Notice of Allowability

09/654,929

AKIYAMA ET AL.

FIG. 2
(AMENDED)

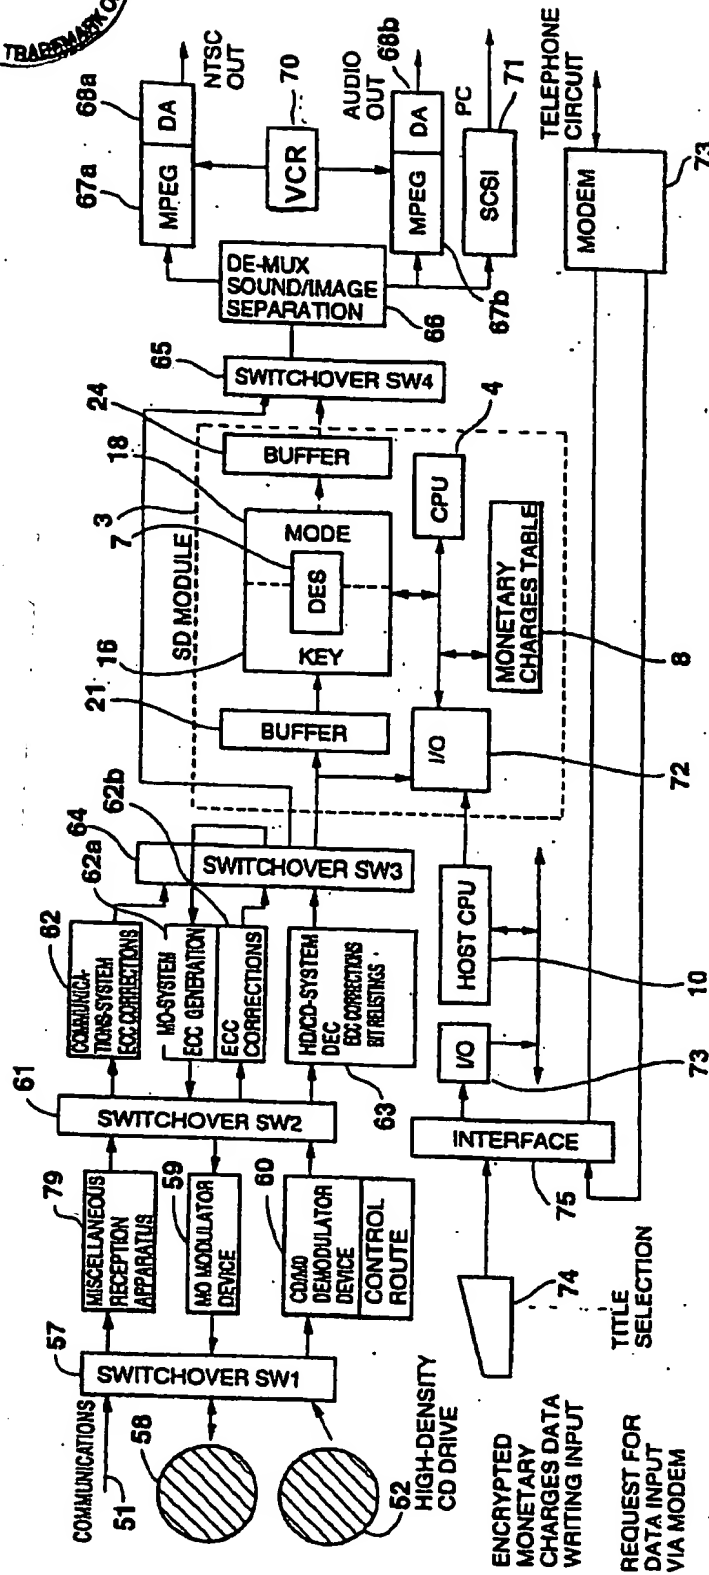
In amended drawings 2 and 7 the word "(AMENDED)" has been placed below the figure number to comply with MPEP 1413.
